Docket Item #8
DEVELOPMENT SPECIAL USE PERMIT #2005-0003
INOVA ALEXANDRIA HOSPITAL

Planning Commission Meeting
July 5, 2005

ISSUE: Consideration of a request for an amendment of a development special use permit, with a site plan, to construct an addition to the existing hospital building.

LOCATION: 4320 Seminary Road

Previous Proposal

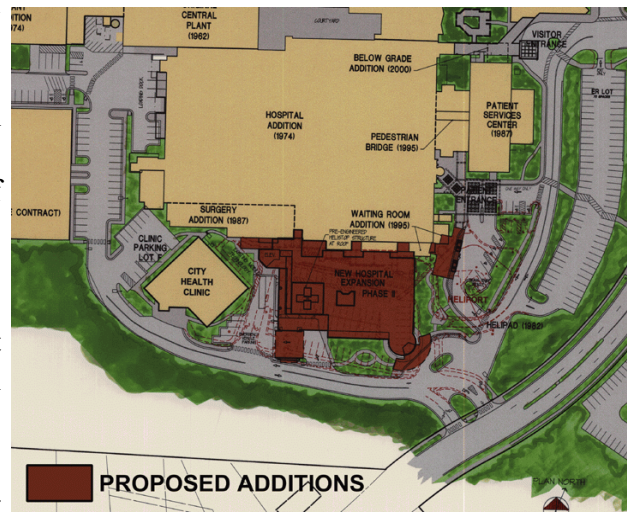
The applicant is proposing a significantly smaller addition and revised circulation than was approved in 2002. The size of the proposed addition was reduced from 55,234 sq. ft. to 34,431 sq. ft., while the building height has remained at 35 ft. The proposed addition will consist of a 4-level addition on the southeast side of the building and a 1-level addition on the southwest side of the building. The 4-level addition will include one floor below grade and one “interstitial” floor that will be inaccessible to the public. The 4-level addition will total approximately 66,784 gross sq. ft., 16,104 sq. ft. of which will be below grade. The uses will include new emergency room space, surgery support, mechanical equipment, and shell space. The 1-level addition on the southwestern portion of the building will total approximately 2,200 sq. ft. and will provide additional operating room space.

Current Proposal

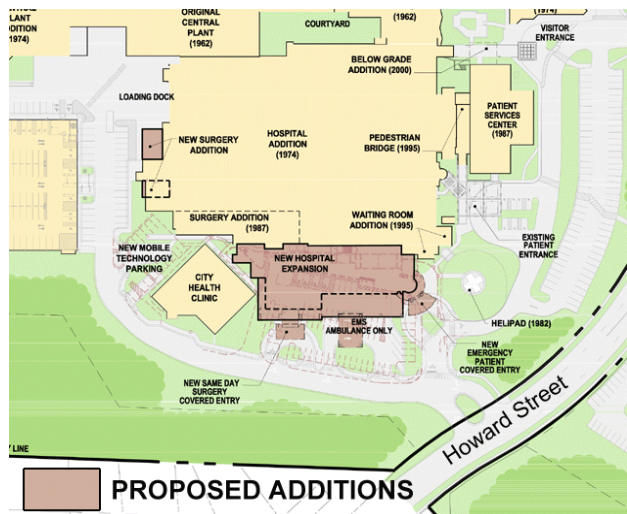
The building addition will include an expanded emergency room with a larger waiting area, additional seating and additional emergency bays. According to the applicant, the existing emergency room is frequently at capacity, causing ambulances to be rerouted to other hospitals in the region. The additional monitored rooms will allow emergency rooms to become more readily available which will enable patients to be served in a more timely manner. The increase of private single rooms will serve patients with infectious diseases, provide space for new technology and equipment, and better accommodate the imbalance in patient gender differences.

Segregated Drop-Offs

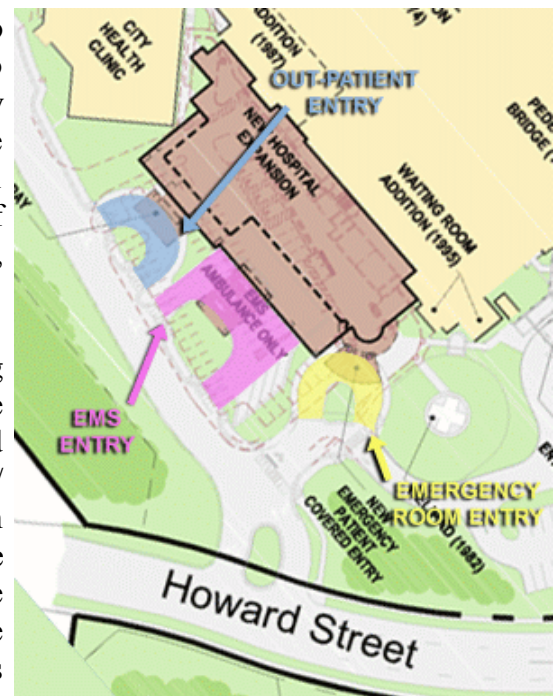
The circulation for the proposed additions is challenging because of the limited space and the goal to retain the landscaped buffer adjacent to the single-family homes and Howard Street. The hospital will have four different visitor/patient drop-off areas, including the emergency room, an E.M.S. loading area, a separate health clinic, an employee parking structure, multiple surface lots, and a high volume of delivery traffic. Working around these challenges, the applicant has designed an internal circulation that segregates the various traffic types and allows for good traffic flow, while also keeping the number of curb cuts at two and leaving the existing landscape buffers intact. The new design also improves on-site pedestrian circulation, and even decreases the total amount of impervious surface – there will be more open space when the construction is completed than exists today.
